SERVICE INSTRUCTION

RUNNING MODIFICATIONS ON

ROTAX® ENGINE TYPE 912/914 (SERIES)

SI-912-020 R2

fig. 1

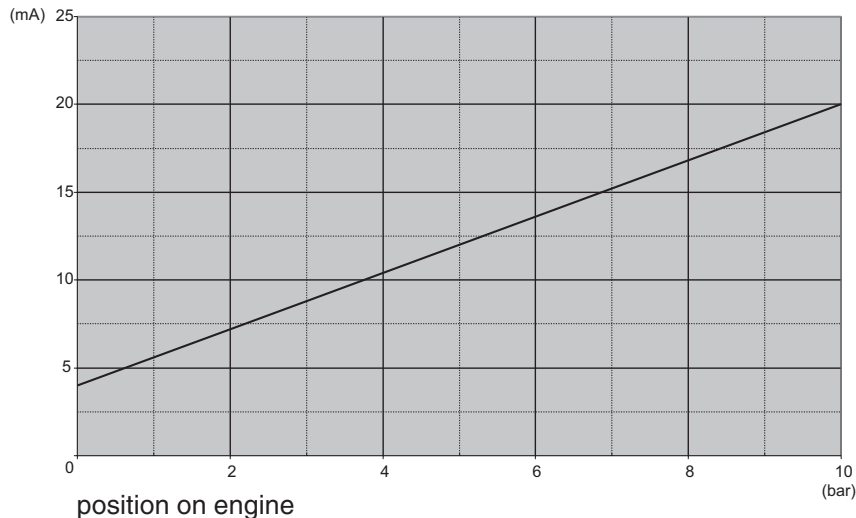
In contrary to the oil pressure sensor offered up to now, which was providing the signal on the basis of a sensor resistance variation, the new oil pressure sensor operates on basis of a current variation. This has to be taken into account for the selection of the appropriate cockpit instrument.

■ **CAUTION:** The graph current over pressure has been determined, and is effective at the following conditions only (see fig. 1).

fig. 2

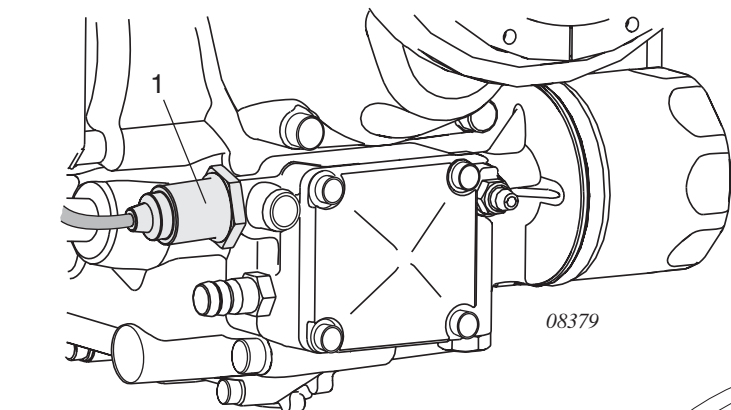
In the course of further development and standardization a new oil pressure sensor part no. 956413 has been introduced.

The sensor cable is approx. 3 m long and has 3 leads. The **Black** lead is not to be connected and has no function. The **Red** lead from the sensor has to be connected to the positive bus via a fuse or circuit breaker. The **White** lead (output signal) has to be connected directly to the instrument. See also the relevant instructions of the instrument supplier/aircraft manufacturer for correct connection and wiring.

fig. 3

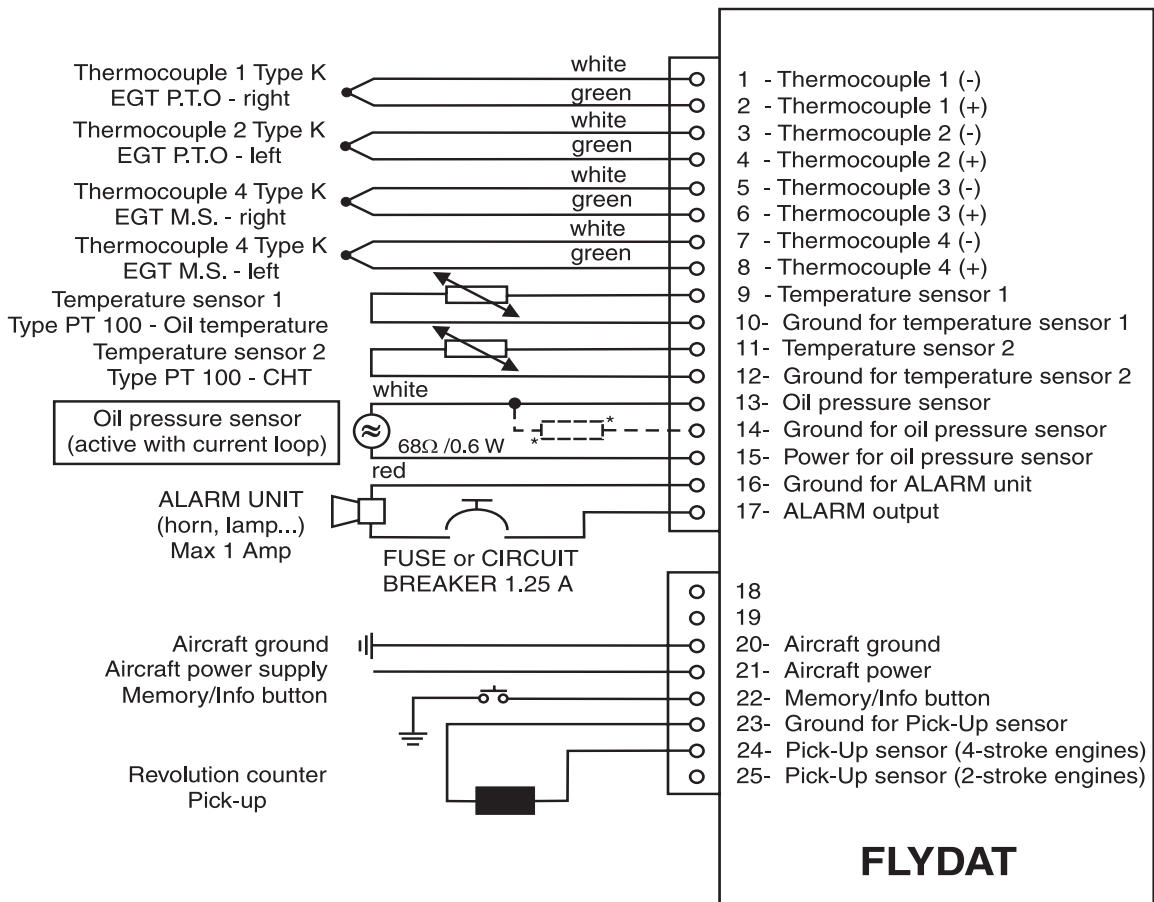
- For the ROTAX® Flydat part no. 886857 a retrofit kit for the electronic oil pressure sensor is offered.

* resistor is part of the retrofit kit for Flydat part no. 886857. See also 1.3.2.
